ITEM: 6.8	COMMITTEE OF ADJUSTMENT REPORT SUMMARY MINOR VARIANCE APPLICATION FILE NUMBER A124/23 58 ED QUIGG WAY, WOODBRIDGE
------------------	--

**COMMITTEE OF ADJUSTMENT REPORT
MINOR VARIANCE APPLICATION
A124/23
58 ED QUIGG WAY, WOODBRIDGE**

ITEM NUMBER: 6.8	CITY WARD #: 2
APPLICANT:	Melissa Rodaro
AGENT:	Action Home Services Inc.
PROPERTY:	58 Ed Quigg Way, Woodbridge
ZONING DESIGNATION:	See below.
VAUGHAN OFFICIAL PLAN (2010) DESIGNATION:	Vaughan Official Plan 2010 ('VOP 2010'): "Low-Rise Residential"
RELATED DEVELOPMENT APPLICATIONS:	None
PURPOSE OF APPLICATION:	Relief from the Zoning By-law is being requested to permit a proposed swimming pool and location of pool equipment.

IN-GROUND POOL ENCLOSURE PERMIT

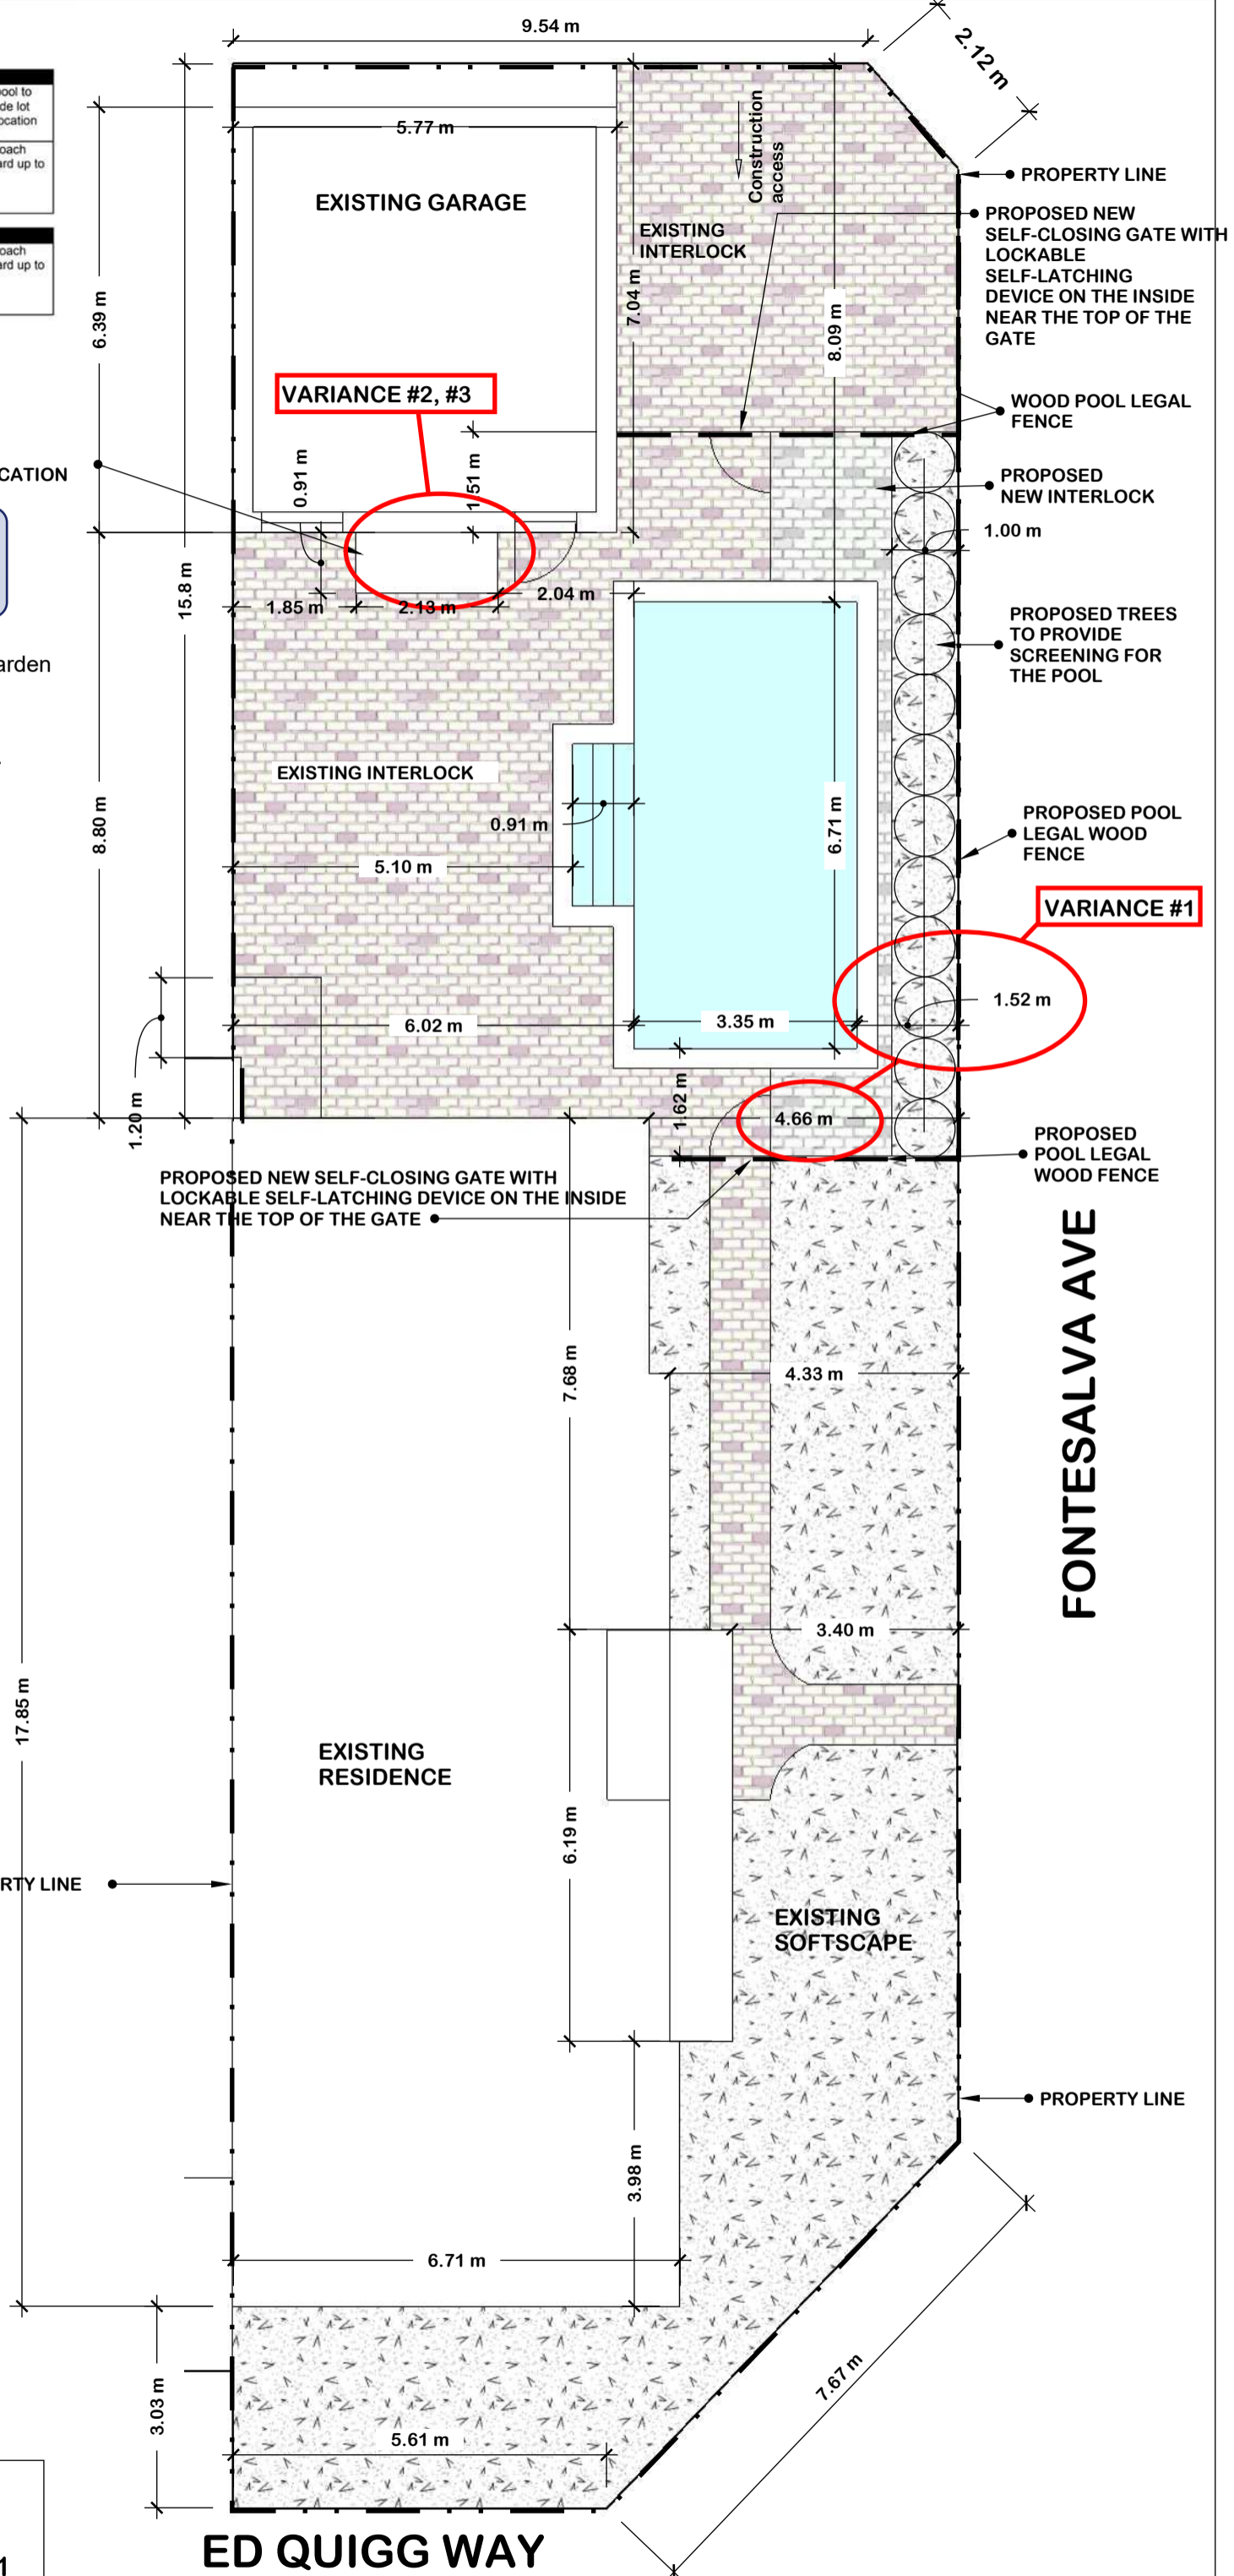
*As Urban Design requested, applicant increased the garden bed (currently 0.61m) to 1m to better support the growth of the trees. Development Planning advised that Zoning Review not required on this update.

The Development Planning Department has no objection to Variance 1 to permit the proposed swimming pool to be located closer to an exterior side lot line than the dwelling. The pool will be screened from the two streets and laneway by the existing privacy fence. Trees are also proposed behind (south) of the fence that runs along exterior side lot line to provide additional privacy. The proposed 1.52 m exterior side lot line setback is sufficient space to accommodate vegetation, and for pool access and maintenance. As such, the proposed pool will not pose any adverse use impacts to the abutting properties.

The Development Planning Department has no objection to Variances 2 and 3 to permit the pool equipment to encroach into the minimum rear yard up to a maximum of 6.0 metres. The proposal maintains sufficient area for access and maintenance and is not anticipated to adversely impact the neighbouring properties. The Development Engineering Department has also reviewed the proposal and is satisfied that drainage will be maintained.
